March 22, 2022

**Re: Aurora Lot 4 - Airport And Alameda (#1592307)/Pre-Application Meeting held December 9, 2021**

- **Section 146-4.7.5 M.6. Drive -Through Screening Adjacent to Street Frontages**

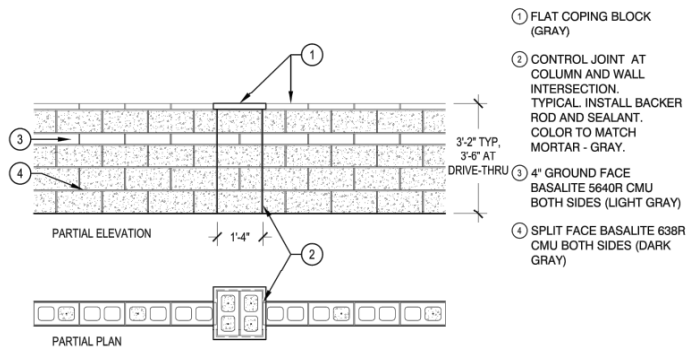
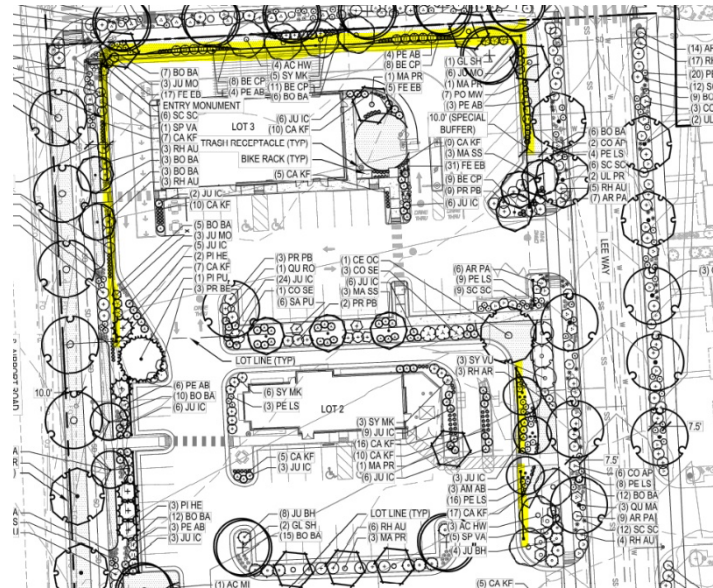
The current layout as proposed meets the intent of the drive-through requirements. Please be advised that should the applicant determine that an alternative layout is warranted and the drive through is no longer internalized within the development, specific screening requirements as outlined in this section of the UDO will be necessary.

**Response: The drive through lane for this site will be lower than the adjacent parking area and a retaining wall, in addition to landscaping, will provide screening.**
